<b>Subject:</b>  <b>MIL ON WITH DTC P0191:00</b>	<b>Bulletin No:</b> 01-010/14
	<b>Last Issued:</b> 04/07/2014

2012-13 Mazda3 (with SKYACTIV 2.0L)

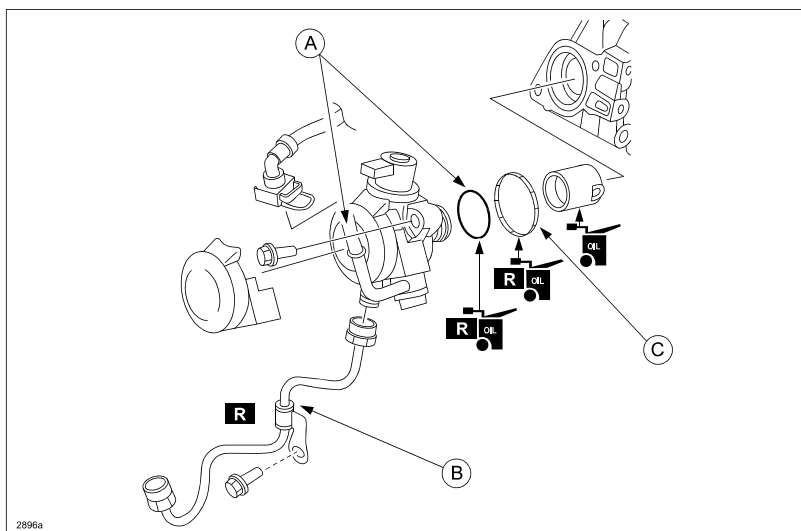
Some vehicles may experience the MIL on with DTC P0191:00 (Fuel pressure sensor circuit range/performance problem) stored in memory. This is caused by the high pressure fuel pump not generating the target fuel pressure (due to a manufacturing error of the inner parts). To correct the problem, production control has been improved.

1. Verify customer concern.
2. Replace the high pressure fuel pump with a modified one according to the Workshop Manual.
3. Replace the high pressure fuel pump (A: fuel pump; B: fuel pipe; C: rubber seal) with a modified one according to the instructions on MS3 online or the Workshop Manual (section 01-14 HIGH PRESSURE FUEL PUMP REMOVAL/INSTALLATION).

Part Number	Description	Qty.	Notes
PE18-20-3F0	Fuel Pump	1	All models
PE01-13-290D	Fuel Pipe	1	2.0L
PY01-13-290A		1	2.5L
PF01-13-555	Rubber Seal	1	All models
